Date: September 11, 2024

Project: Courtice Mixed Use Seniors Development at 1697 Highway # 2

Addendum No. 1

Mechanical Addendum No. M1

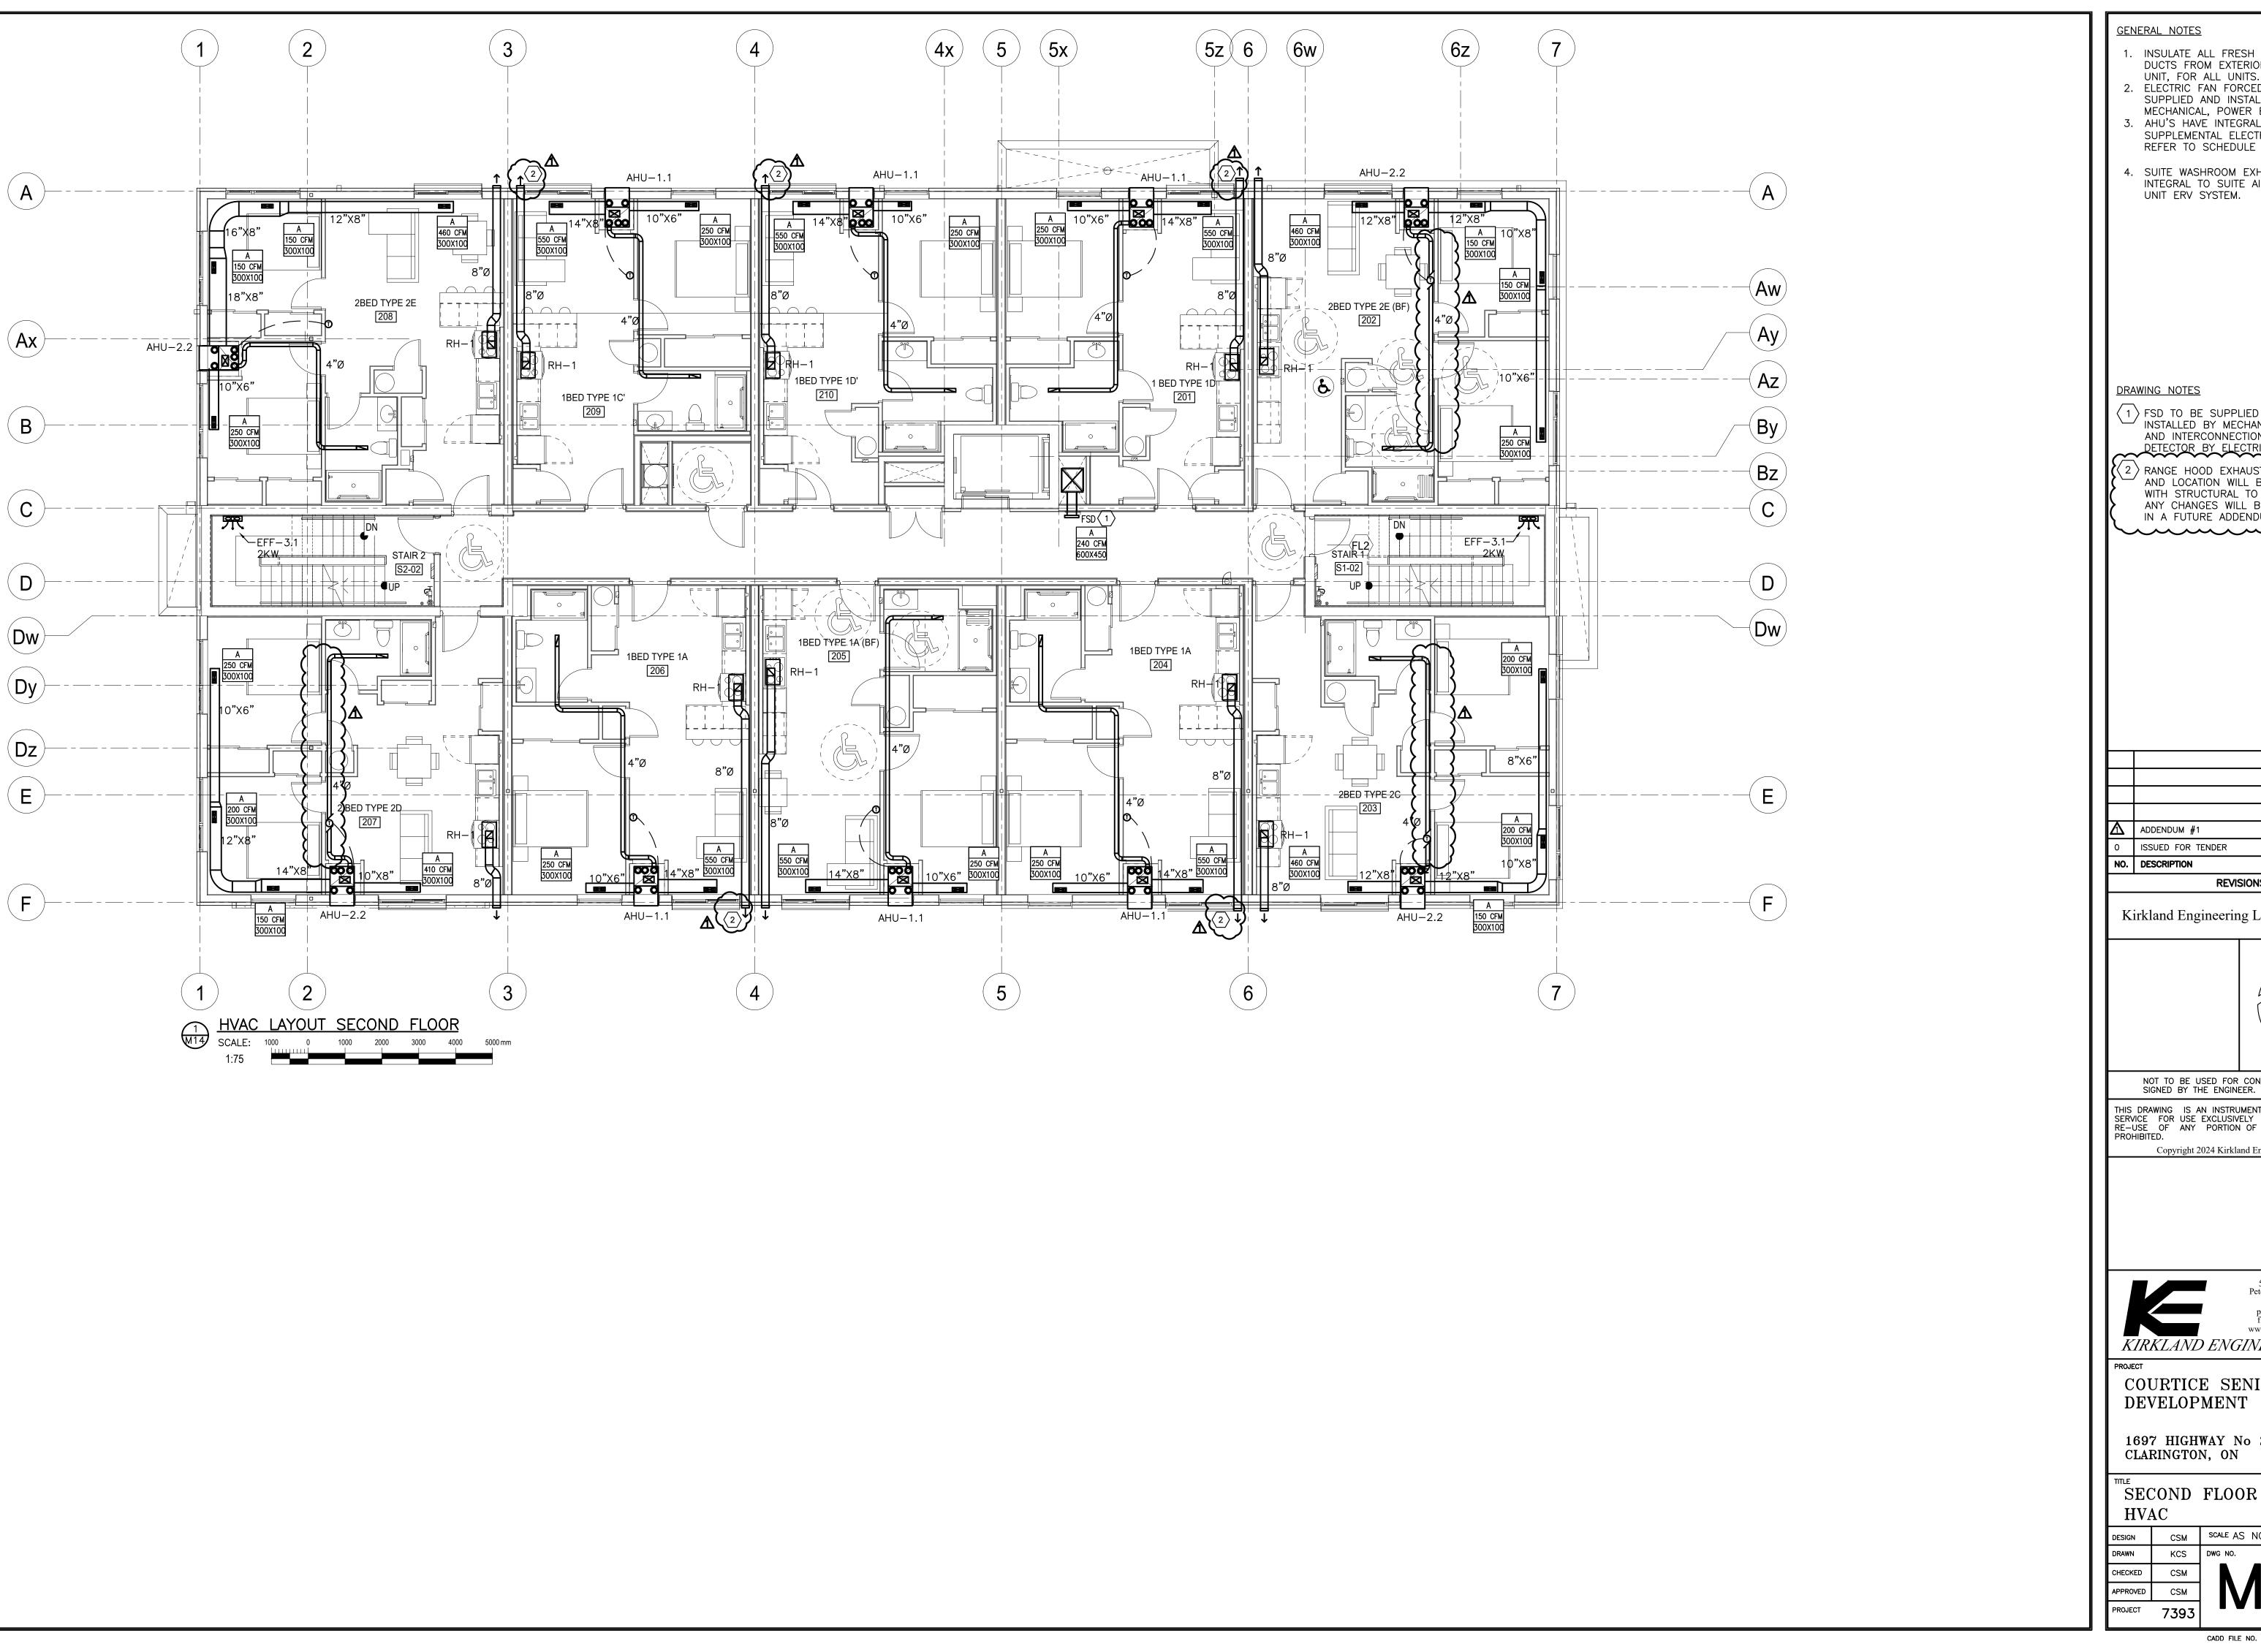
.1 Duct Layout Revision. Refer to Kirkland Engineering Ltd.'s Drawing No. M14 dated September 9, 2024.

- 1. Some suite range hood exhaust routing adjusted to coordinate with lintel. Changes bubbled on drawing.
- 2. Some suite ERV return ducting adjusted to fit in bulkhead (by architectural). Changes bubbled on drawing.

THIRD FLOOR DESIGN

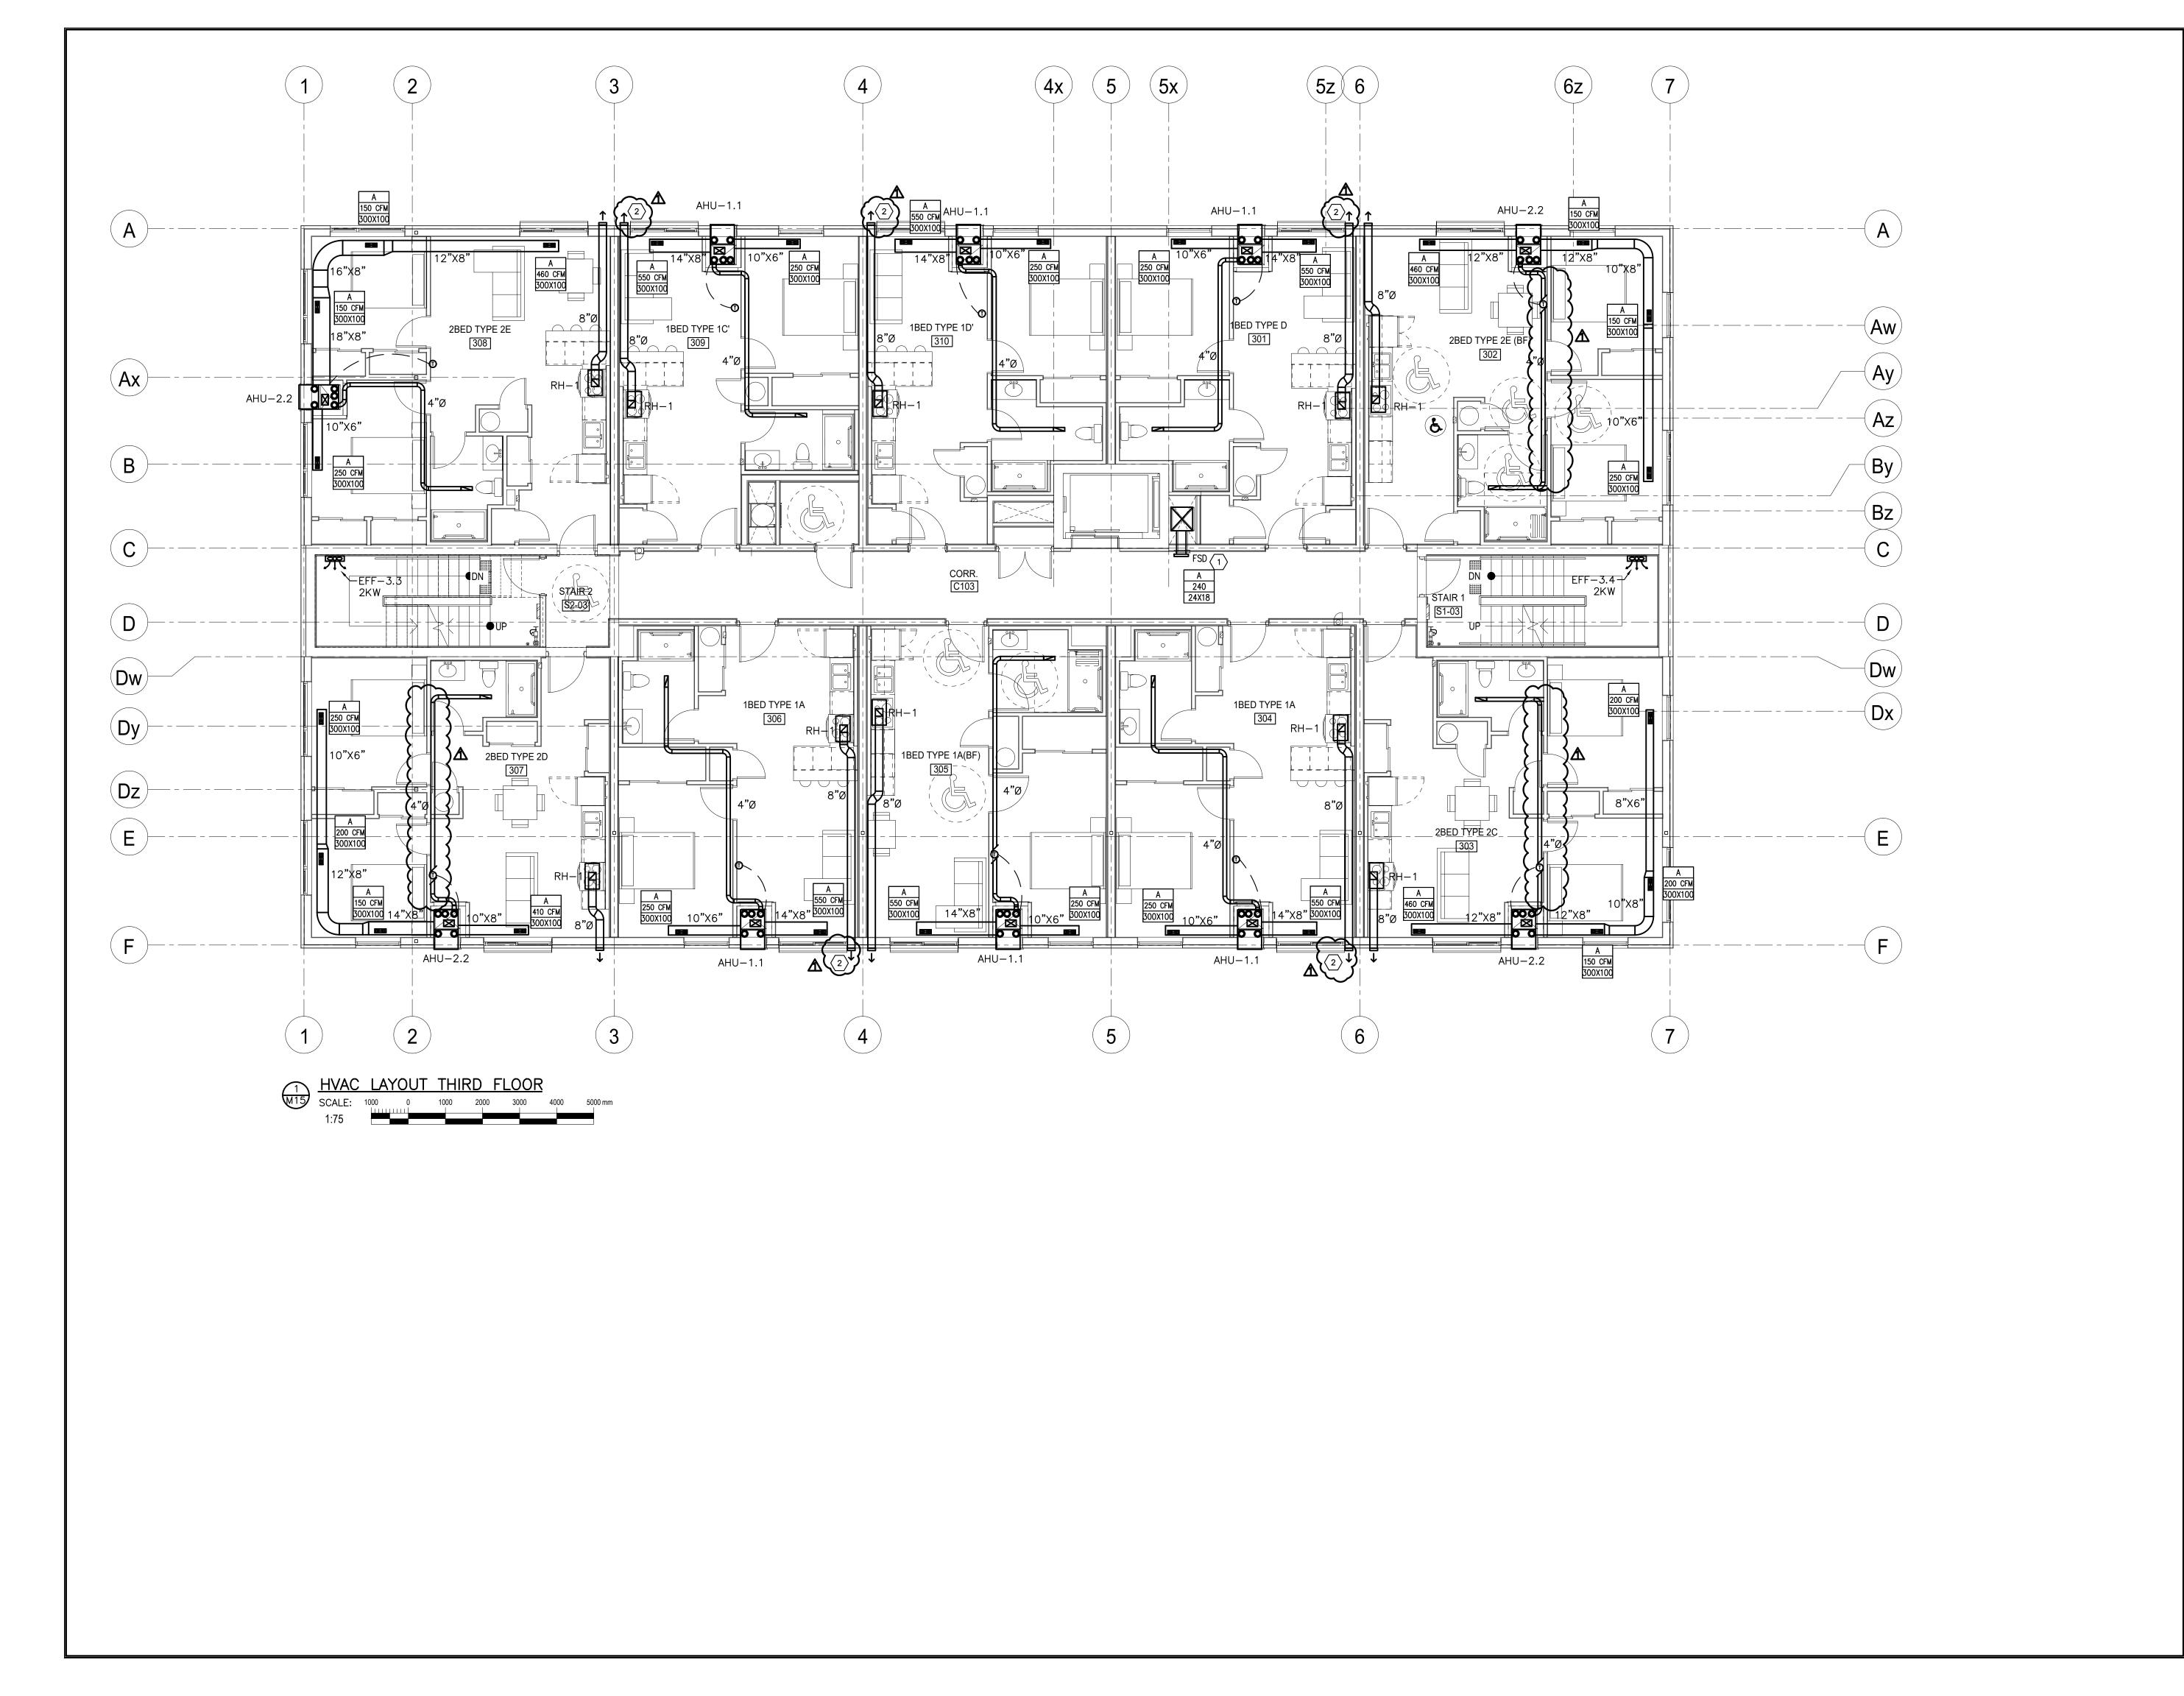
.1 Duct Layout Revision. Refer to Kirkland Engineering Ltd.'s Drawing No. M15 dated September 9, 2024.

FOURTH FLOOR

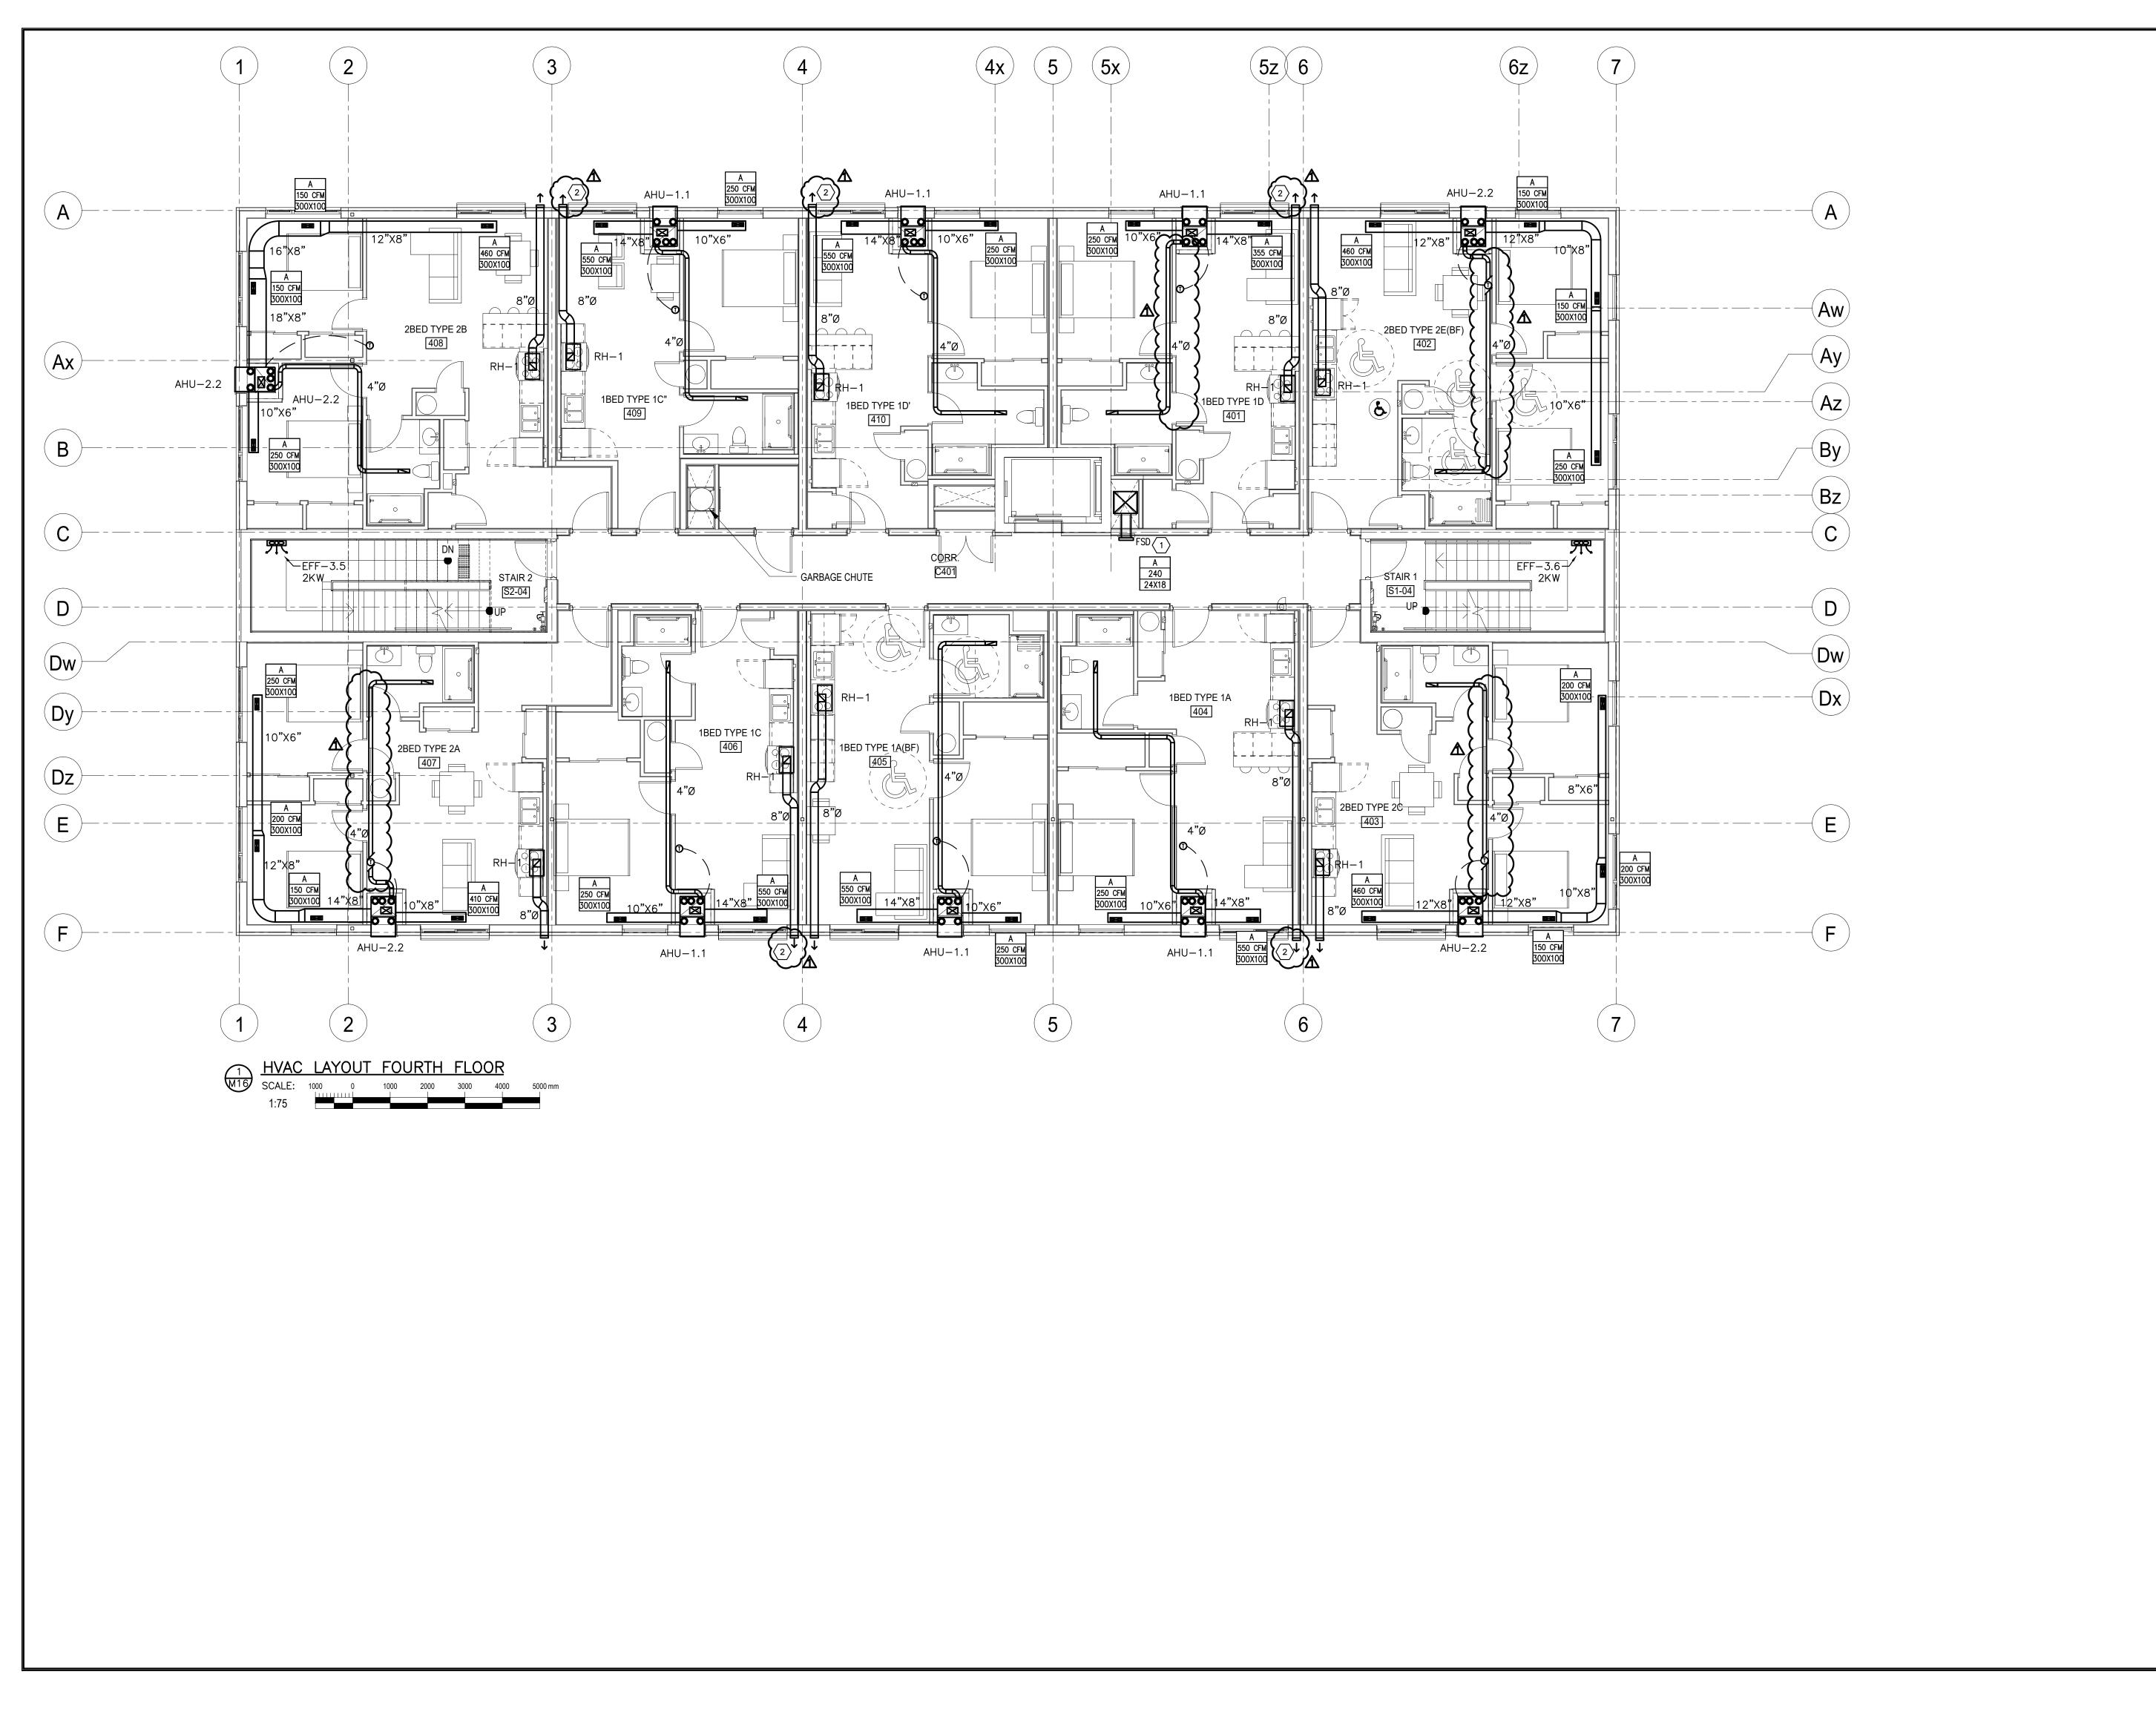
.1 Duct Layout Revision. Refer to Kirkland Engineering Ltd.'s Drawing No. M16 dated September 9, 2024.
